### STAFF RECOMMENDATION 3812 Central Avenue January 20, 2016

**Application:** Partial demolition; New construction—addition  
**District:** Richland-West End Neighborhood Conservation Zoning Overlay  
**Council District:** 24  
**Map and Parcel Number:** 10312027100  
**Applicant:** Anna Teeples  
**Project Lead:** Melissa Baldock, [melissa.baldock@nashville.gov](mailto:melissa.baldock@nashville.gov)

**Description of Project:** Application is to demolish a non-historic addition and to construct a new rear addition.

sheet title:  
**SITE** residential site plan

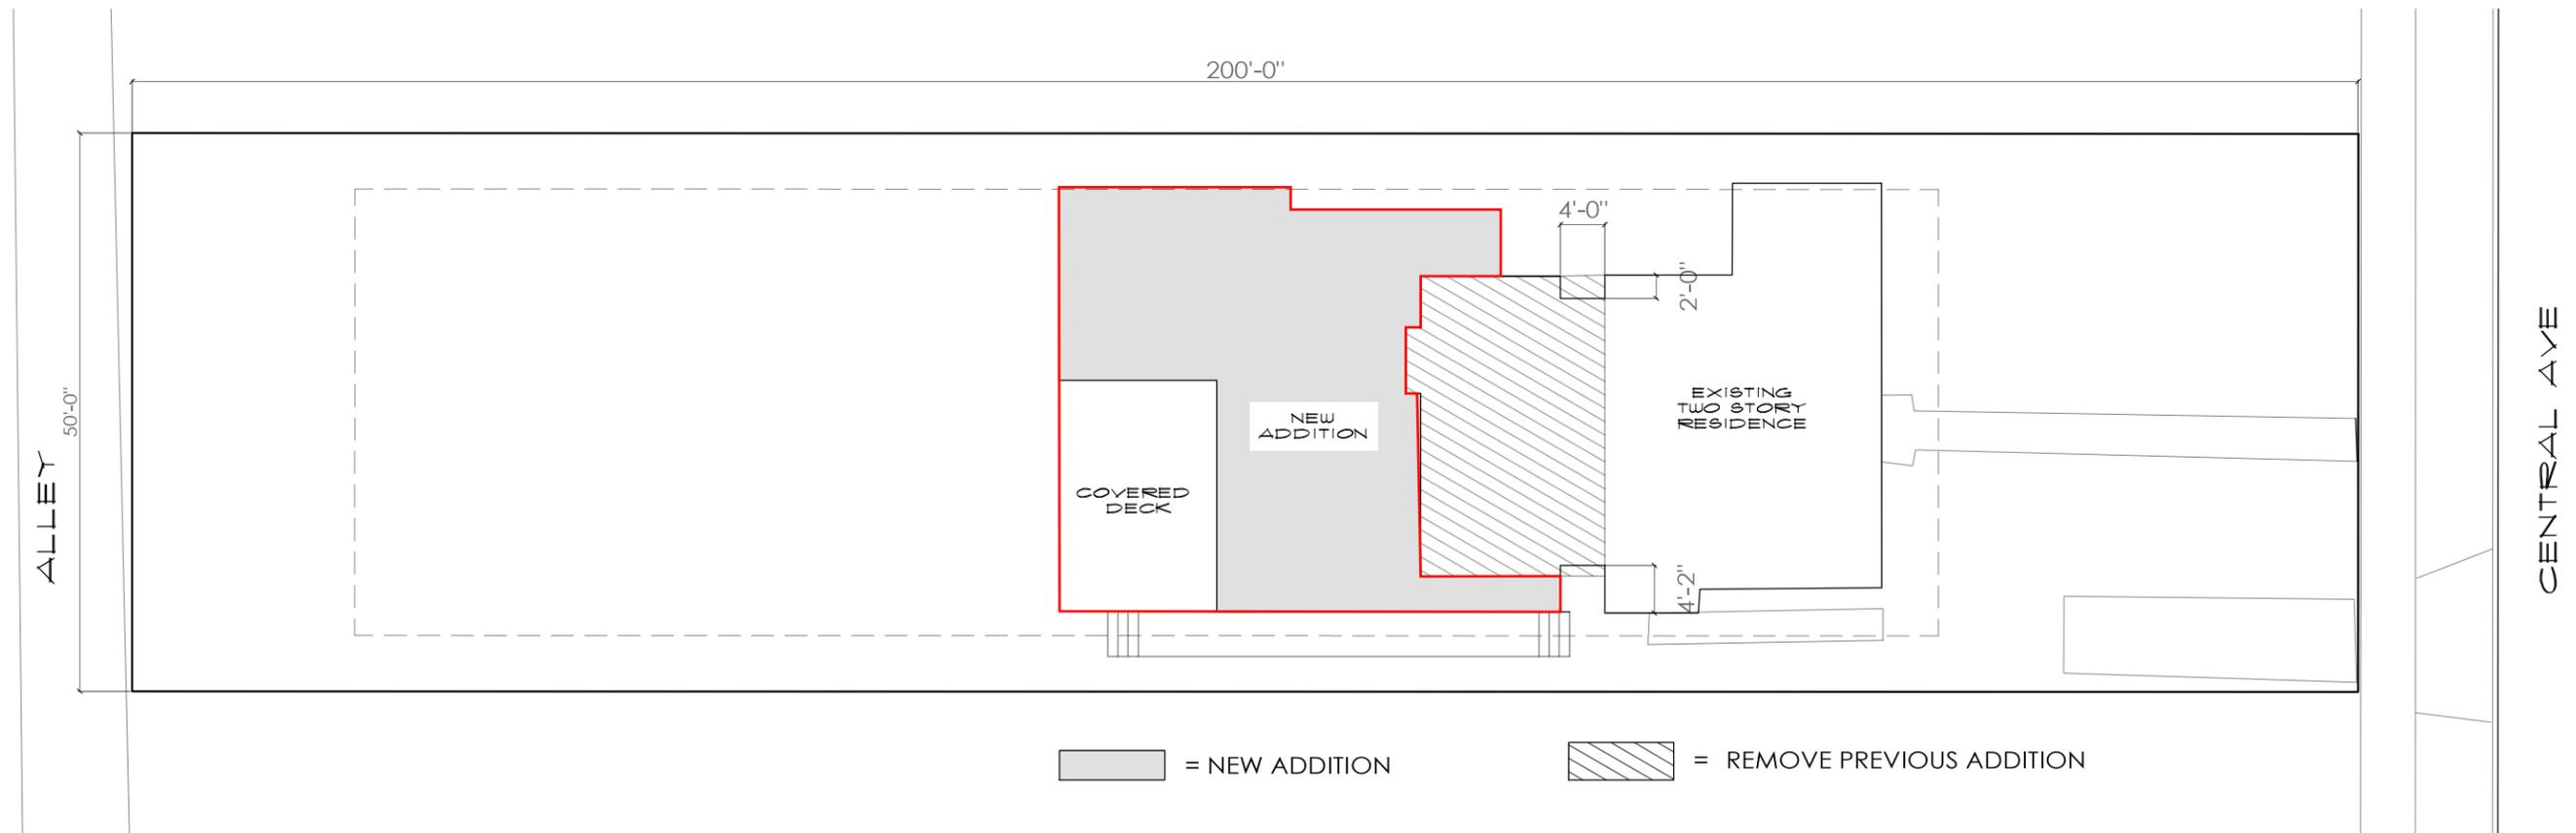
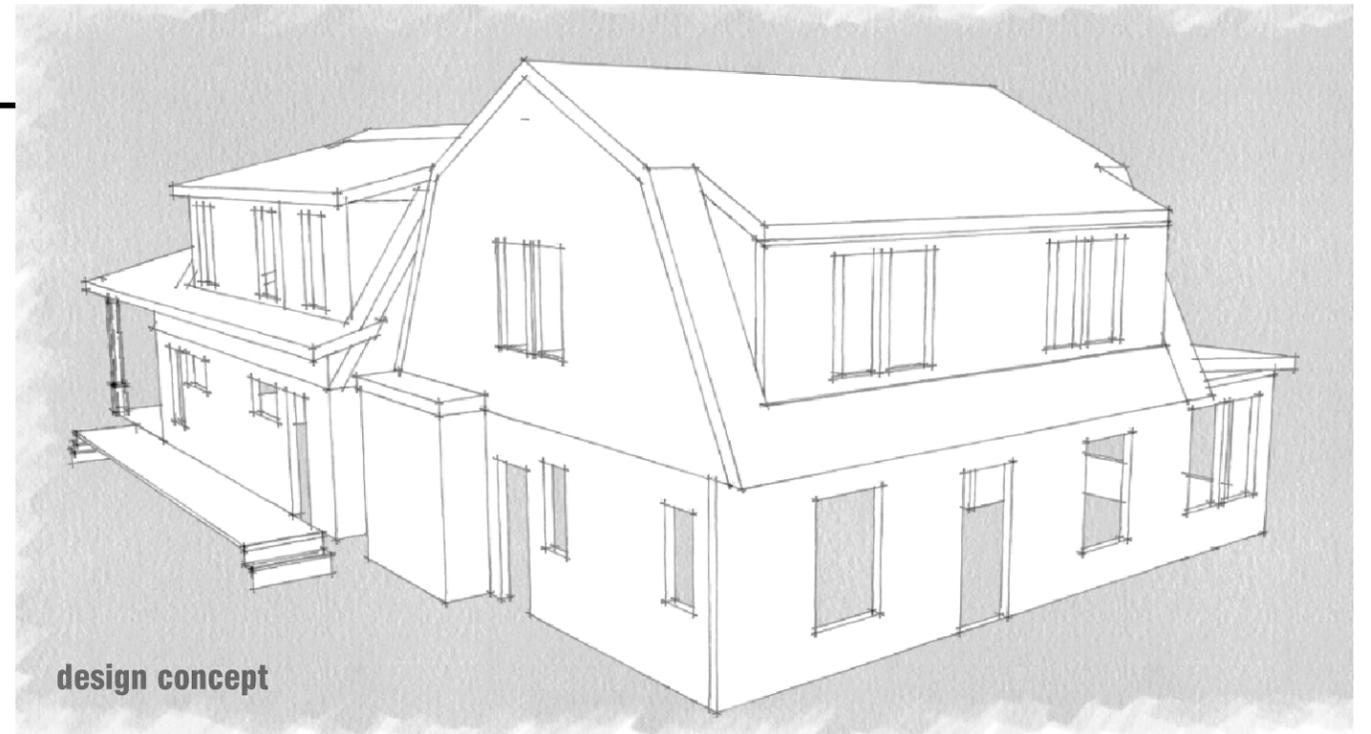
Setback & Rhythm of Spacing: The new addition meets all base zoning setbacks. On the right side, it will be located five feet (5') from the side property line. On the left side, it will be located seven feet (7') from the side property line. It will be located over eighty feet (80') from the rear property line. Because the addition is located behind the historic house and is no wider than the historic house, it will not affect the historic house's rhythm of spacing. Staff finds that the project meets Sections II.B.1.c. and II.B.2. of the design guidelines.

sheet title:  
**A-4** side elevation : residence

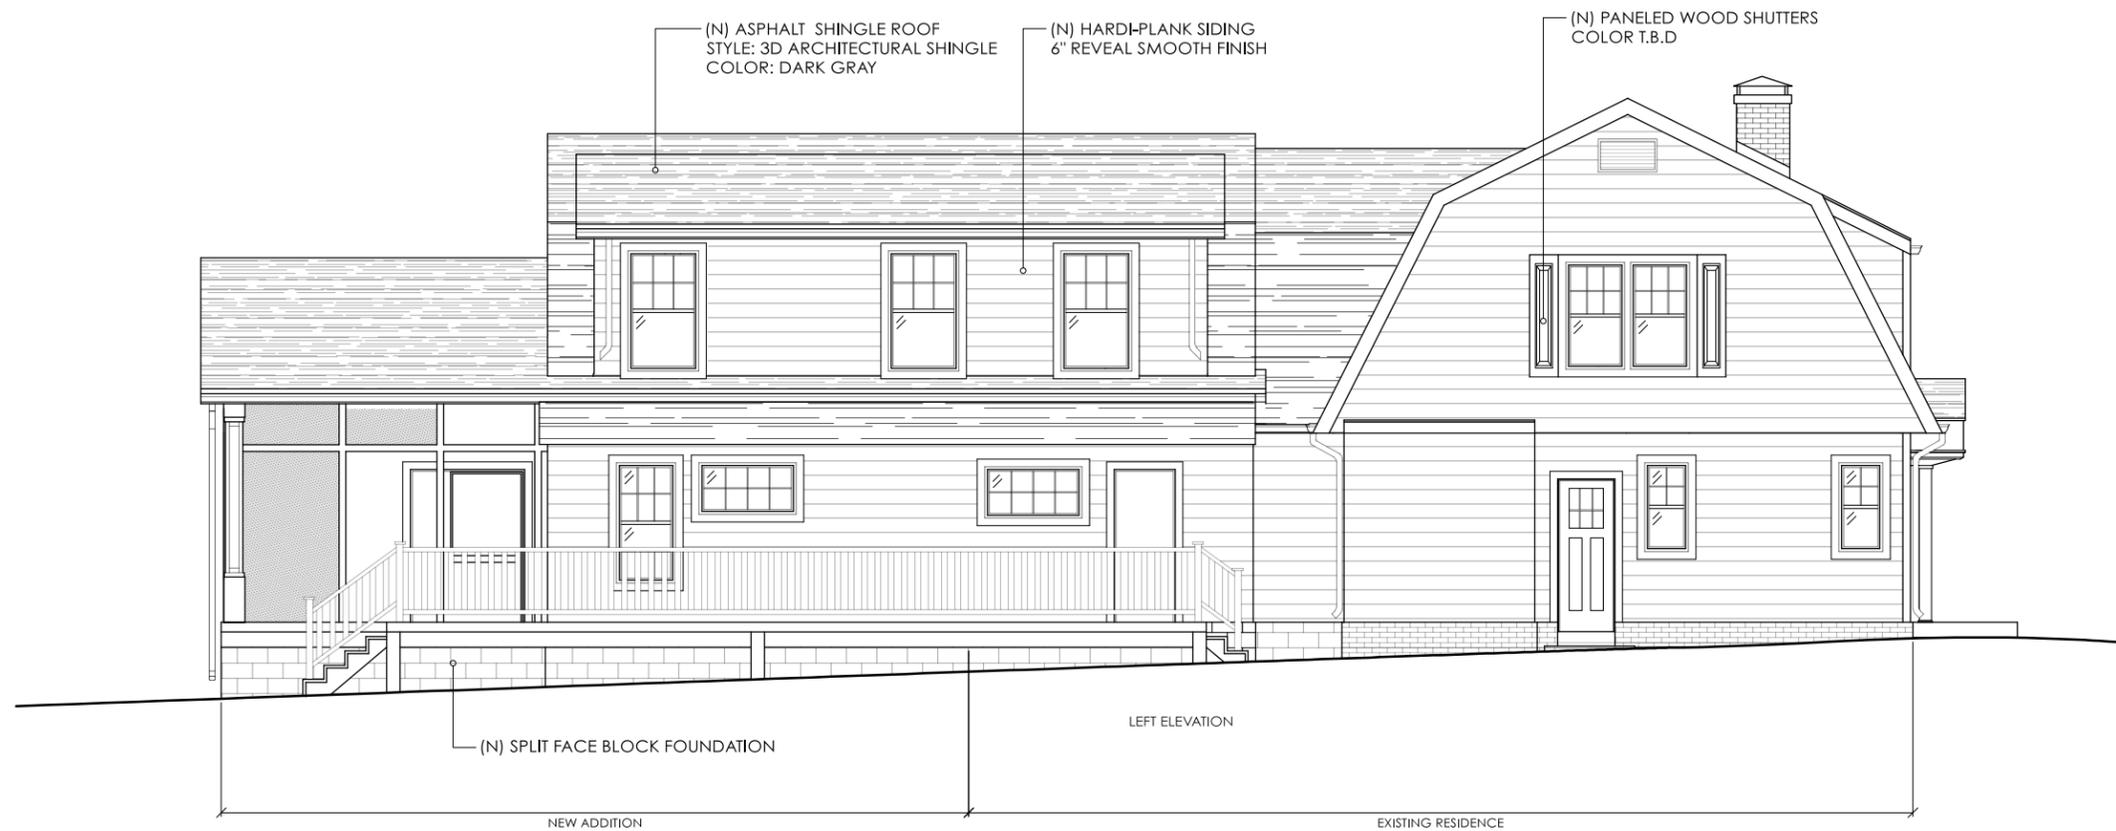
On the left elevation, the applicant also plans to remove a non-historic exterior stair (Figures 7 & 8). In addition, the existing, non-historic doorway on the second level of the left facade will be removed and the siding restored.

Height & Scale: The proposed addition will be no taller and no wider than the historic house. On the left side, the addition steps in four feet (4') from the back wall of the house for a depth of four feet (4'). After the inset, the first story steps back out four feet (4') to match the line of the back portion of the house. The second story will be a dormer that is inset two feet (2') from the wall below it. This second story dormer will line up with the wall of the second story portion of the historic house.

sheet title:  
**A-6** side elevation : residence

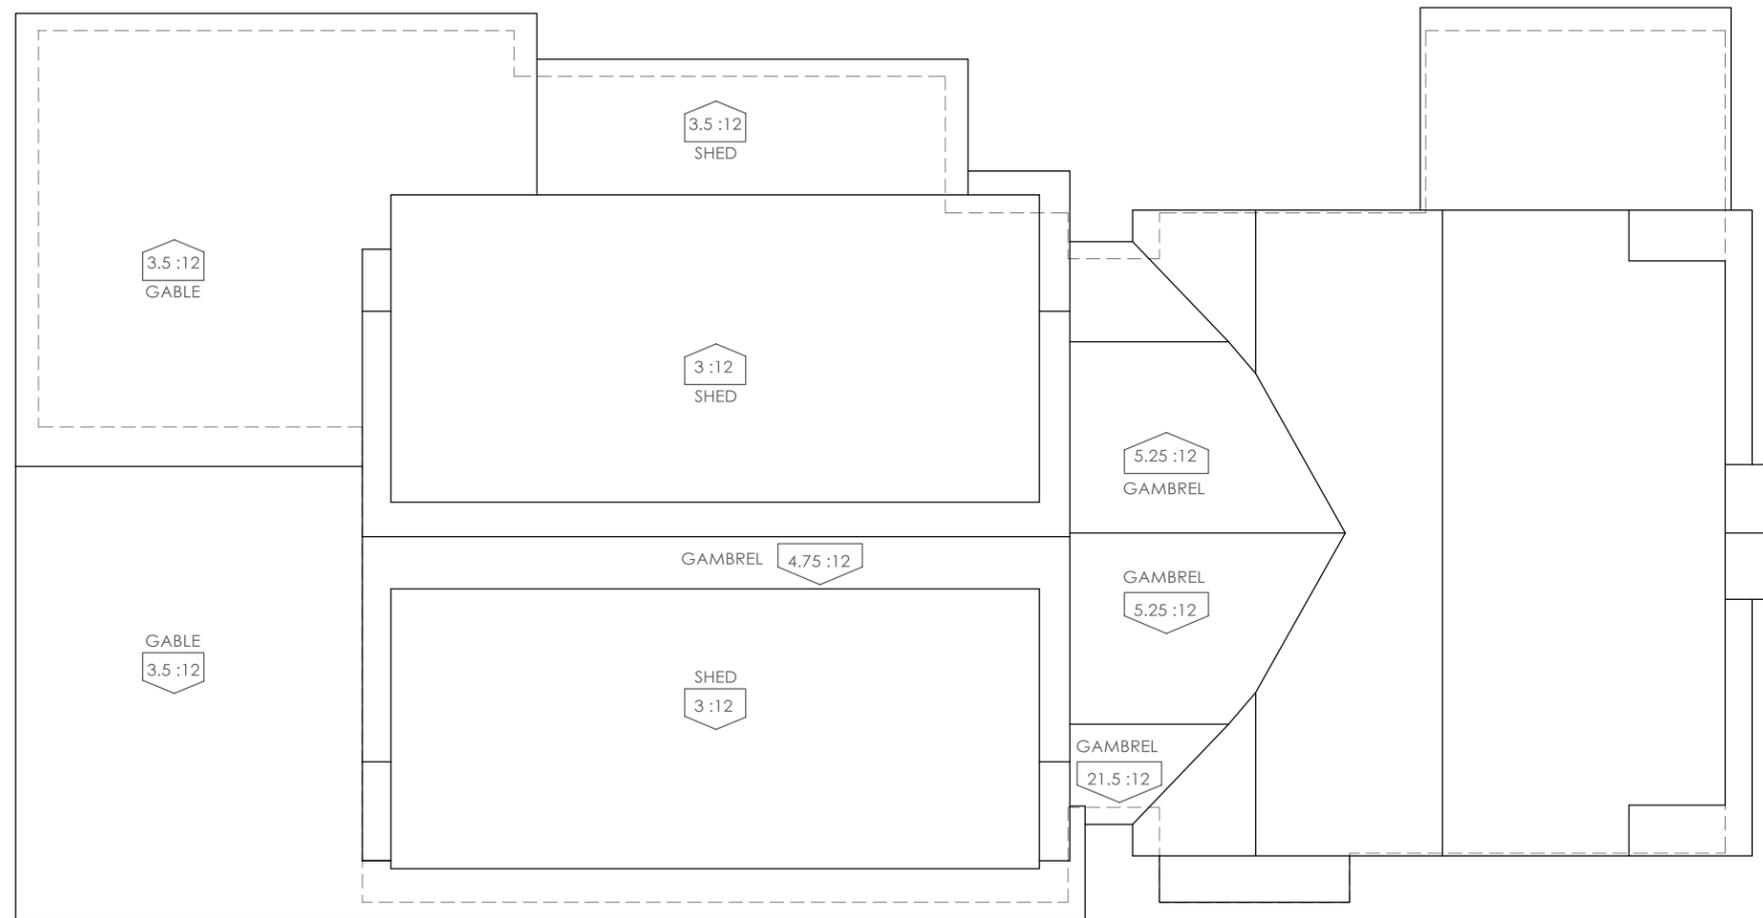
On the right side, the addition is inset two feet (2') for a depth of four feet (4'). After the inset, the addition lines up with the main two-story wall of the house. The first story, however, does extend out to line up with the one-story sunroom at the front of the house. The addition will approximately double the footprint of the existing house.

Roof form: The historic house has a gambrel roof form. The project includes restoring the gambrel roof form on the right elevation. The addition will tie into the back of the historic house with a gambrel roof with a primary slope of approximately 5/12. Beyond the connector roof will be another gambrel roof form with a slope of approximately 5/12. This roof will have 3/12 shed dormers that are inset two feet (2') from the wall below. The rear portion of the addition will have a gable roof with a 3.5/12 slope. Staff finds that the proposed roof forms are compatible with the historic house and meet Sections II.B.1.e. and II.B.2. of the design guidelines.
